MIL-B-46506D
 AMENDMENT 6
 04 January 1994
 SUPERSEDING
 AMENDMENT 5
 18 March 1991

MILITARY SPECIFICATION
 BOXES, AMMUNITION PACKING,
 WOOD, WIREBOUND

This amendment forms a part of Military Specification MIL-B-46506D, dated 30 August 1984, and is approved for use by all the Departments and Agencies of the Department of Defense.

FIGURE 1A.
9(24)

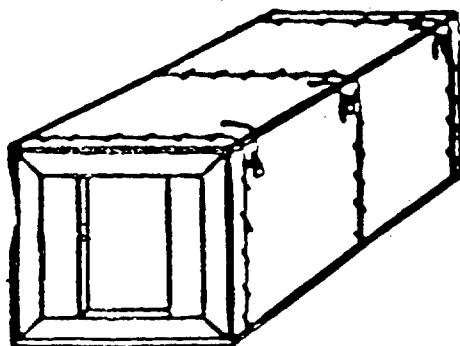
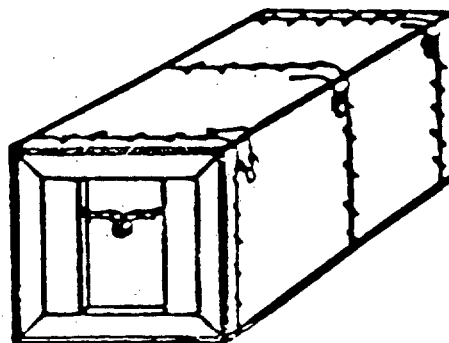
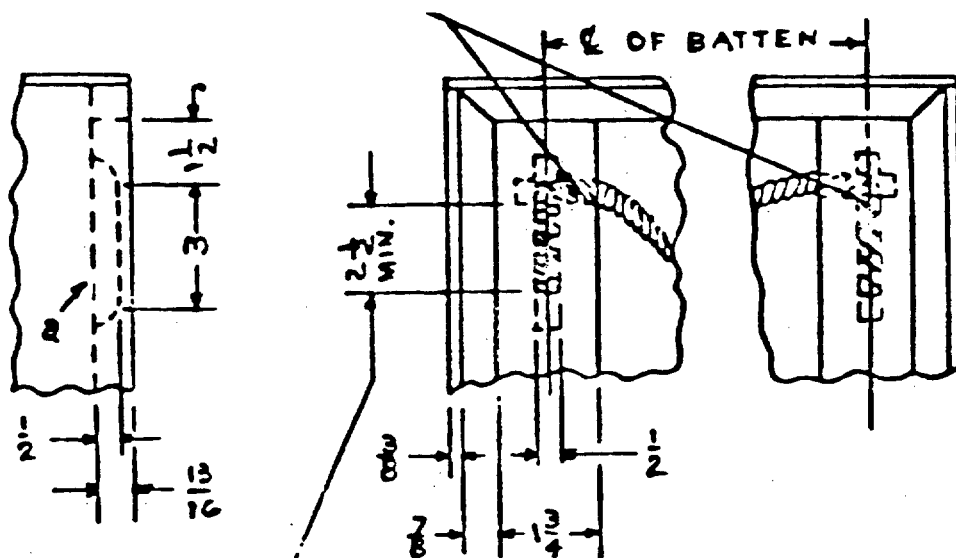
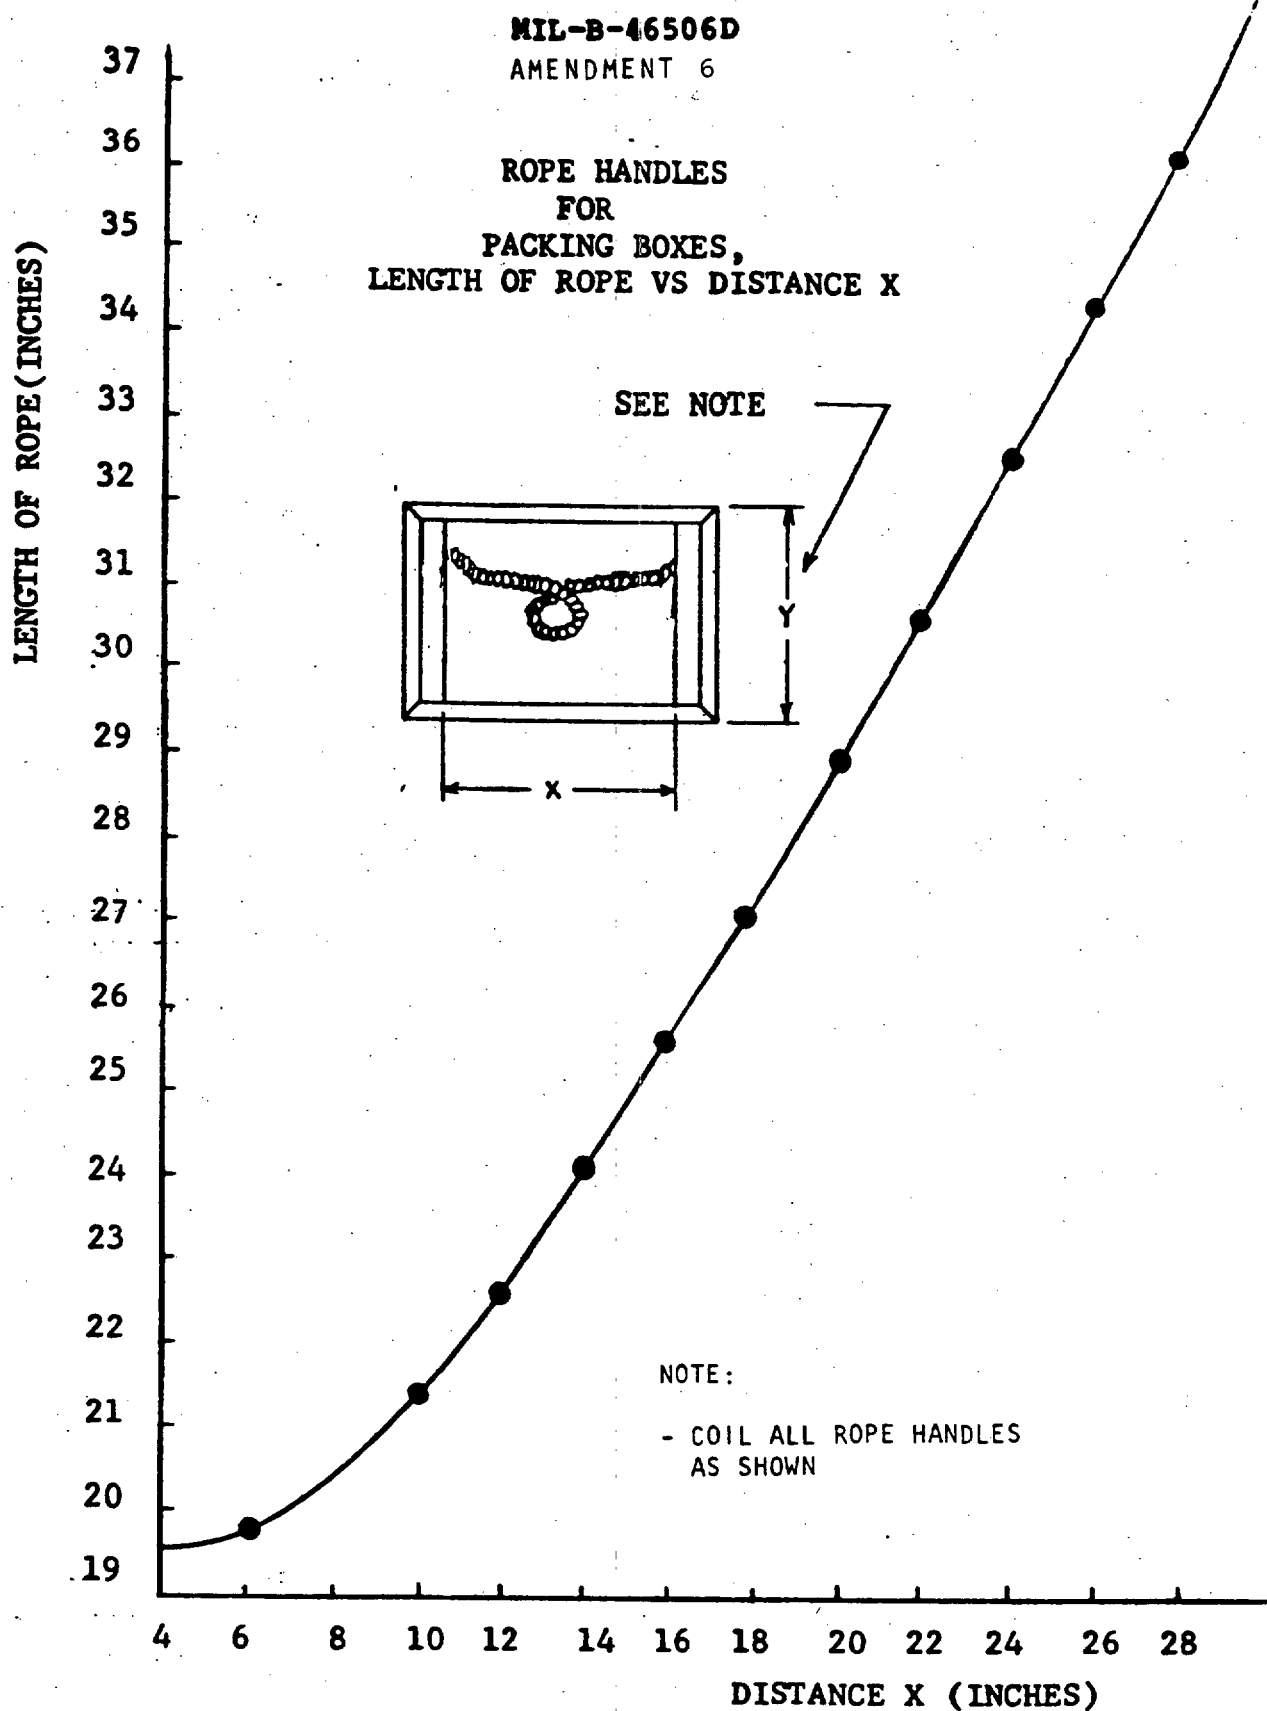
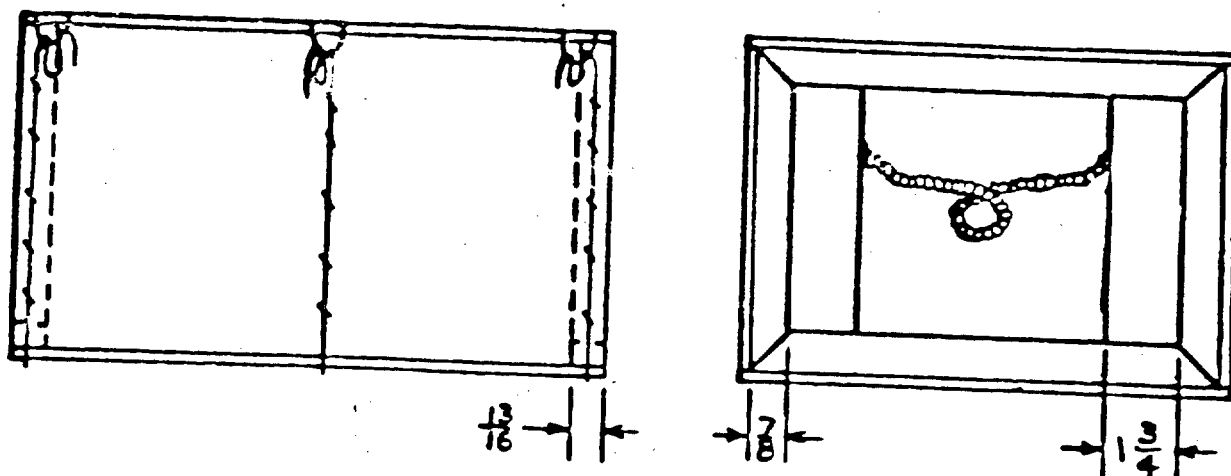
Figure 1A. Delete in its entirety and substitute the included figure 1A.
